PRAIRIE ISLAND NUCLEAR GENERATING PLANT, UNIT NO. 1

Amendment No. 129  
License No. DPR-42

ATTACHMENT TO LICENSE AMENDMENT NO. 129

PRAIRIE ISLAND NUCLEAR GENERATING PLANT, UNIT NO. 2

FIGURE TS.3.8-1 Spent Fuel Pool Unrestricted Region Burnup and Decay Time Requirements - OFA Fuel

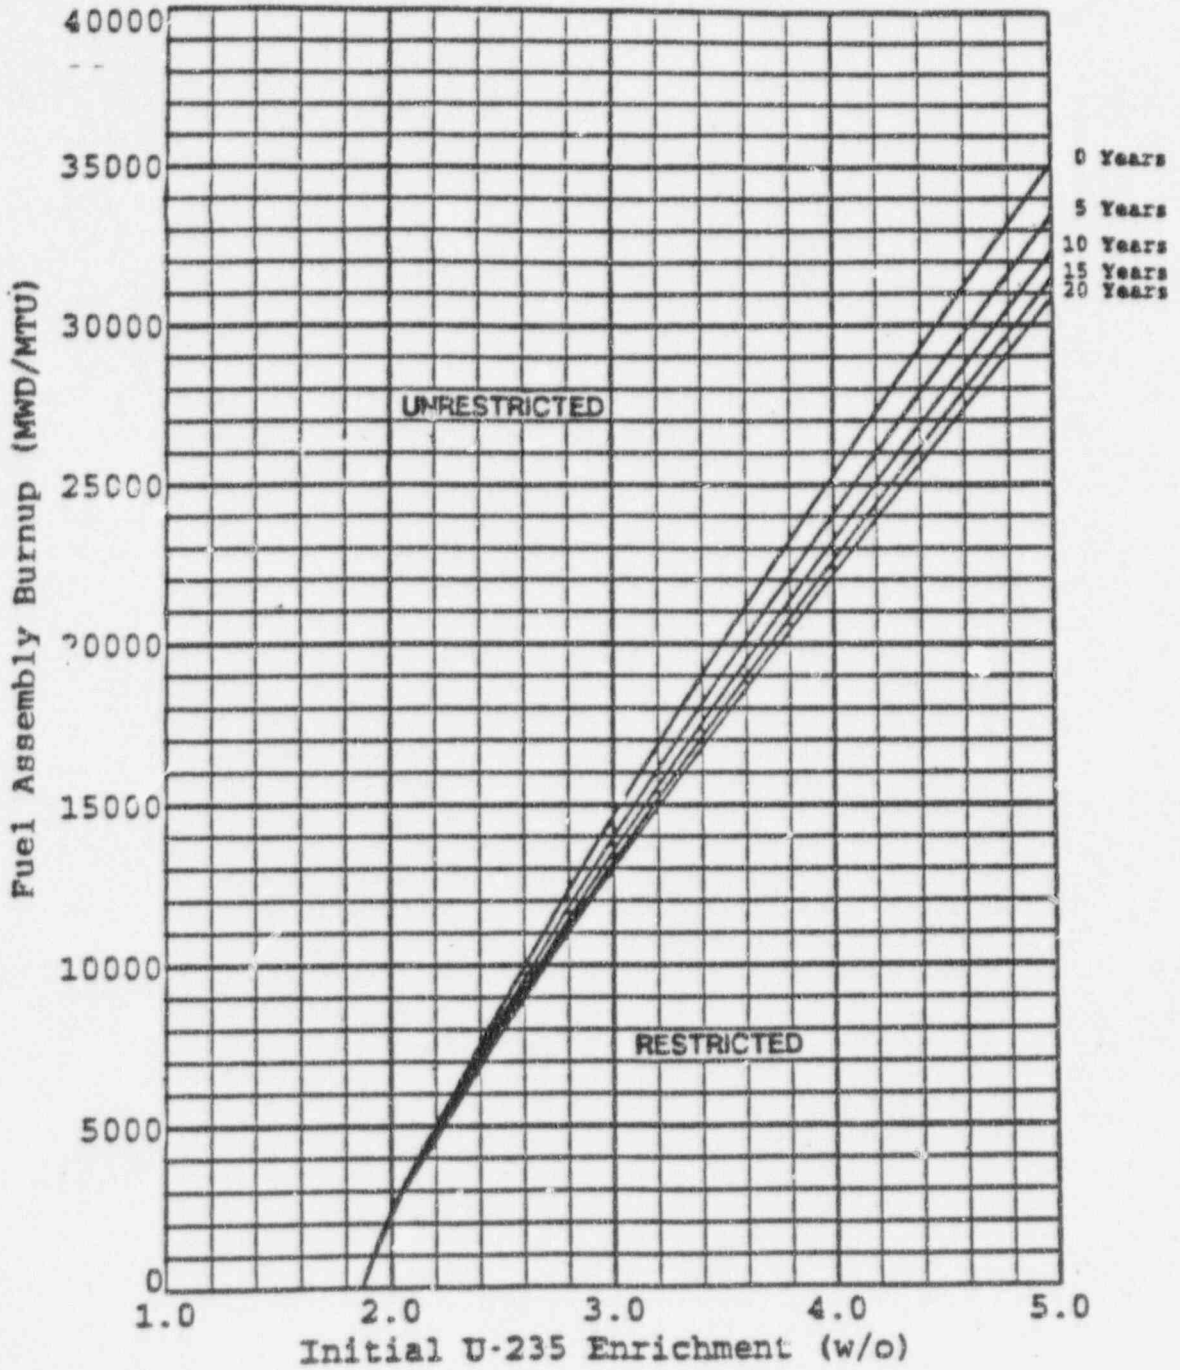
- a. The combination of initial enrichment, burnup and decay time of each spent fuel assembly stored in the spent fuel pool shall be within the unrestricted range of Figures TS.3.8-1 or TS.3.8-2, as applicable, or fuel assemblies shall be stored in accordance with Specification 5.6.A.1.e.
- b. If the requirements of 3.8.E.1.a are not met, immediately initiate action to move any noncomplying fuel assembly to an acceptable location.
- c. The provisions of Specification 3.0.C are not applicable.

FIGURE TS.5.6-1 Spent Fuel Pool Burned/Fresh Checkerboard Cell Layout

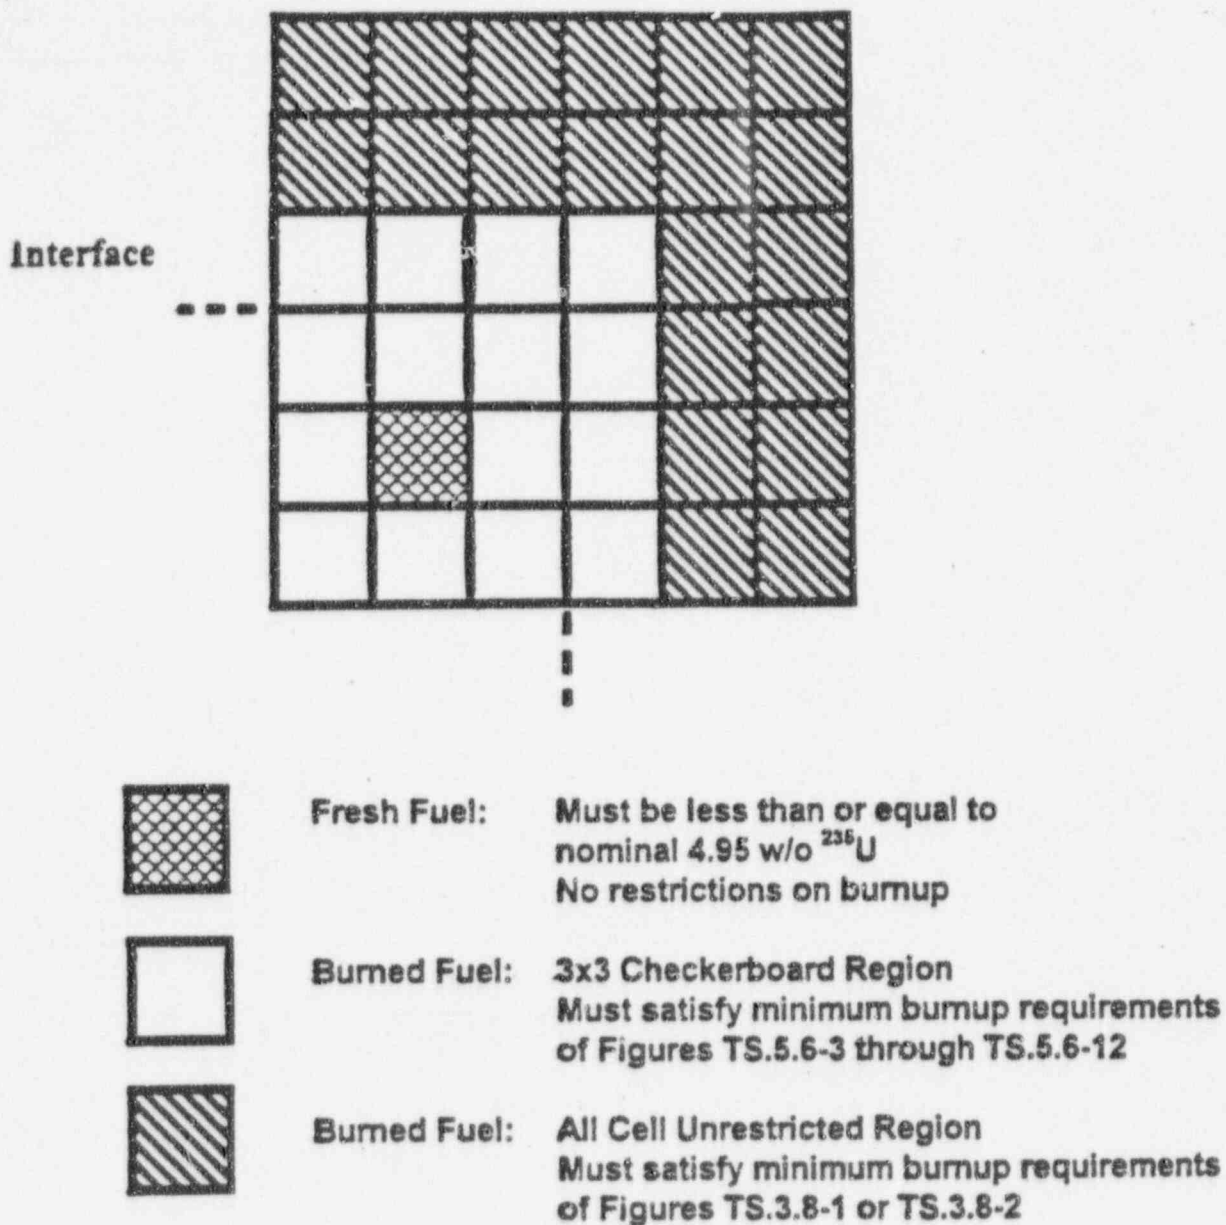
Fuel assemblies that fall into the restricted range of Figures TS.3.8-1 or TS.3.8-2 are required to be stored in "fresh" cell locations as shown in Figure TS.5.6-1. The criteria included in Figures TS.3.8-1 and TS.3.8-2 for the selection of fuel assemblies to be stored in the "fresh" cell locations is based on a combination of fuel assembly type, initial enrichment, decay time and discharge burnup.

FIGURE TS.5.6-2 Spent Fuel Pool Checkerboard Interface Requirements

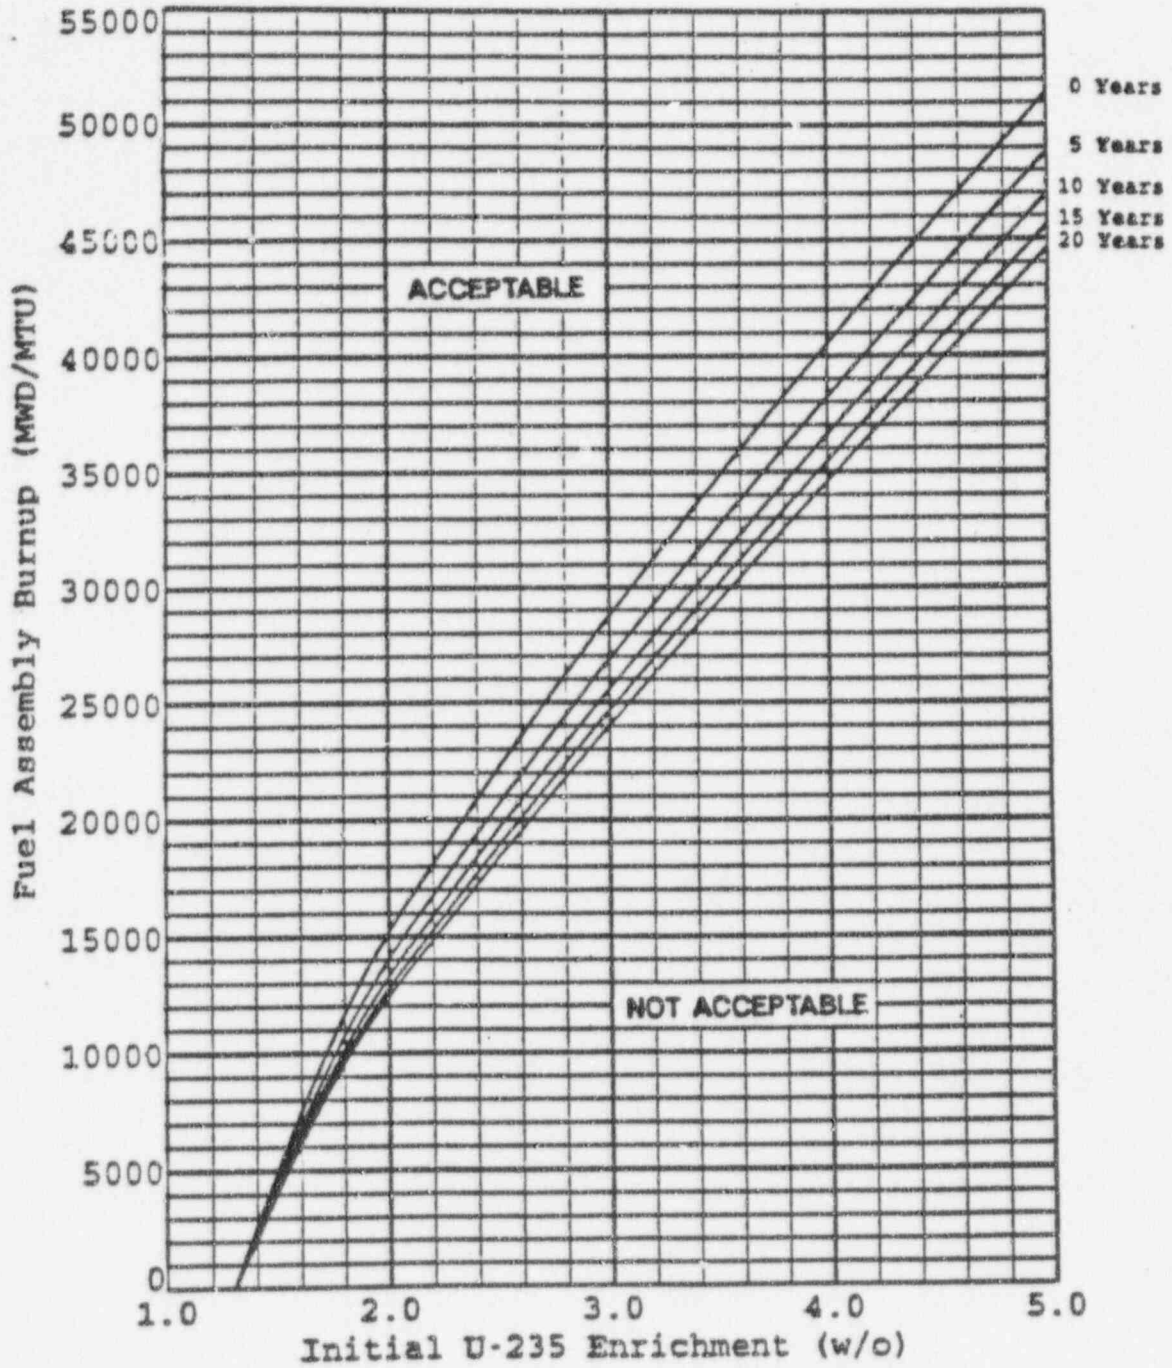
1. separated by a vacant row of cells, or
2. the interface must be configured such that there is one row carryover of the pattern of burned assemblies from the checkerboard region into the first row of the unrestricted region (Figure TS.5.6-2).

FIGURE TS.3.8-1 Spent Fuel Pool Unrestricted Region Burnup and Decay Time Requirements - OFA Fuel

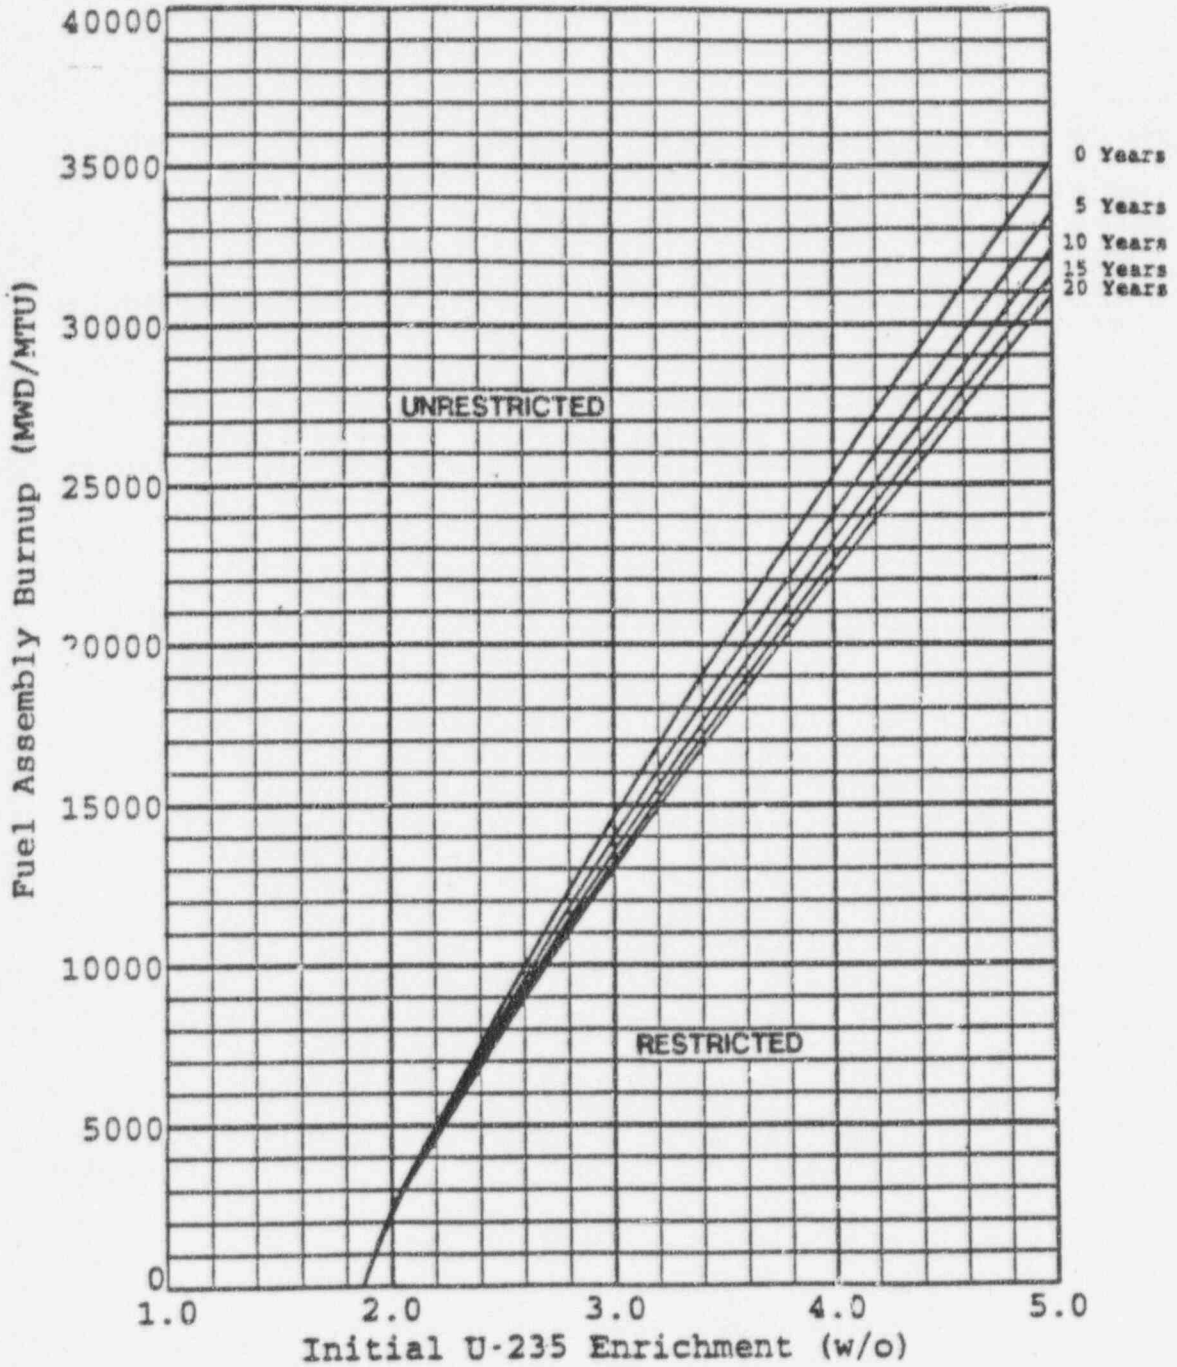
- a. The combination of initial enrichment, burnup and decay time of each spent fuel assembly stored in the spent fuel pool shall be within the unrestricted range of Figures TS.3.8-1 or TS.3.8-2, as applicable, or fuel assemblies shall be stored in accordance with Specification 5.6.A.1.e.
- b. If the requirements of 3.8.E.1.a are not met, immediately initiate action to move any noncomplying fuel assembly to an acceptable location.
- c. The provisions of Specification 3.0.C are not applicable.

FIGURE TS.5.6-1 Spent Fuel Pool Burned/Fresh Checkerboard Cell Layout

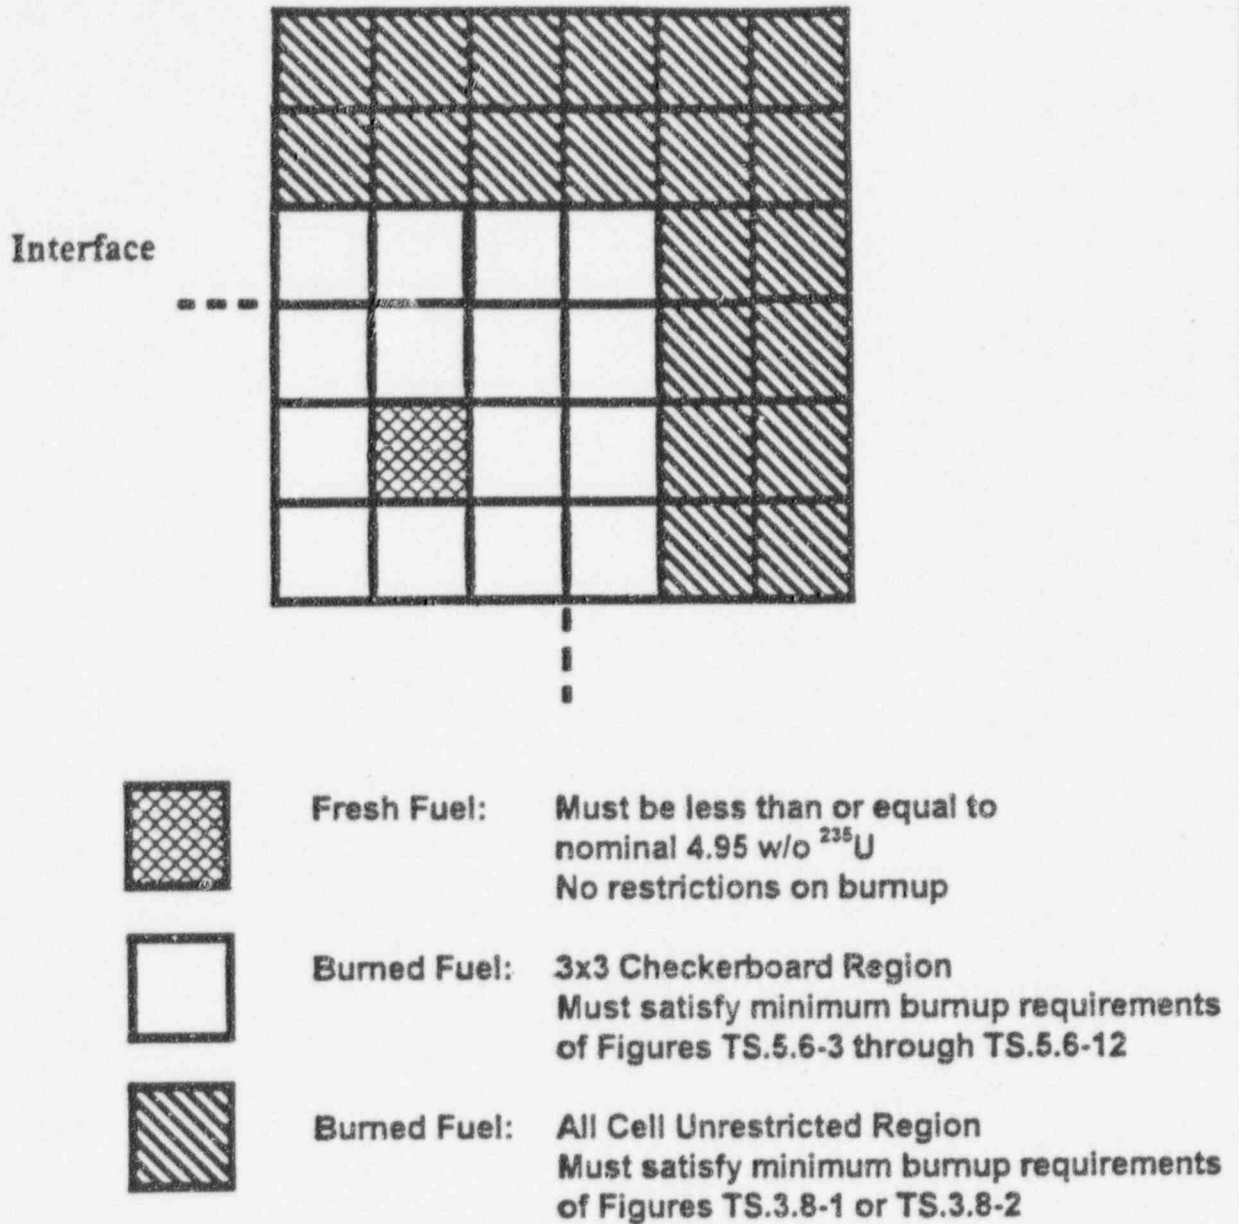
Fuel assemblies that fall into the restricted range of Figures TS.3.8-1 or TS.3.8-2 are required to be stored in "fresh" cell locations as shown in Figure TS.5.6-1. The criteria included in Figures TS.3.8-1 and TS.3.8-2 for the selection of fuel assemblies to be stored in the "fresh" cell locations is based on a combination of fuel assembly type, initial enrichment, decay time and discharge burnup.

FIGURE TS.5.6-2 Spent Fuel Pool Checkerboard Interface Requirements

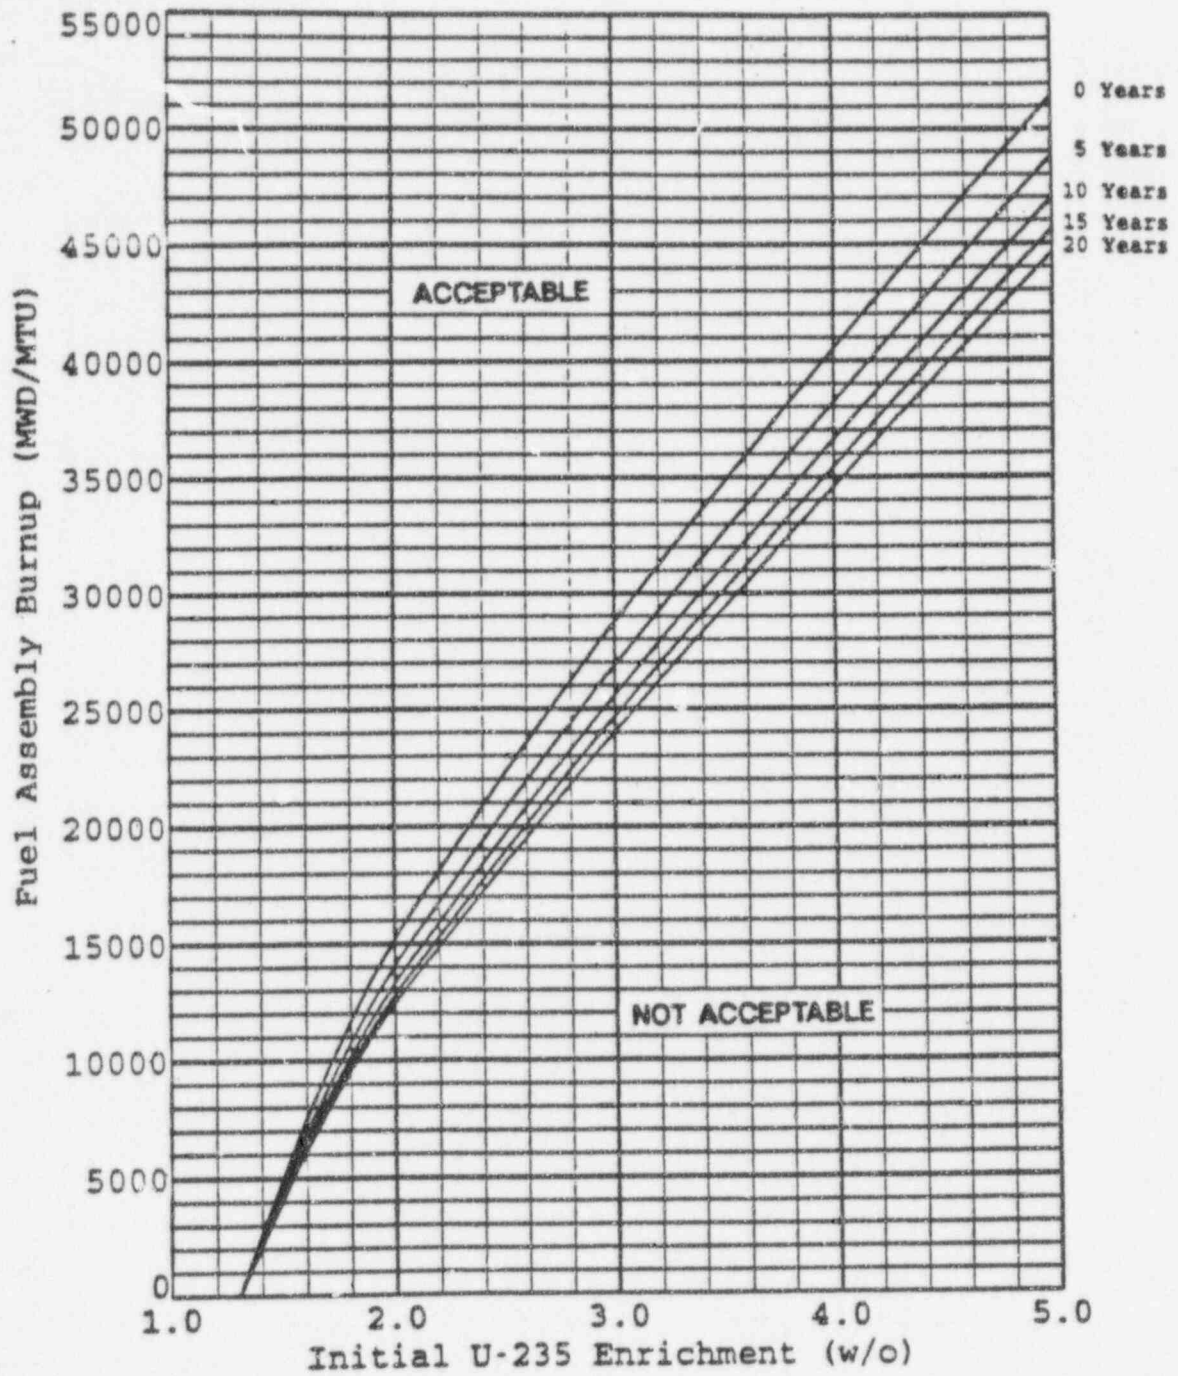
1. separated by a vacant row of cells, or
2. the interface must be configured such that there is one row carryover of the pattern of burned assemblies from the checkerboard region into the first row of the unrestricted region (Figure TS.5.6-2).
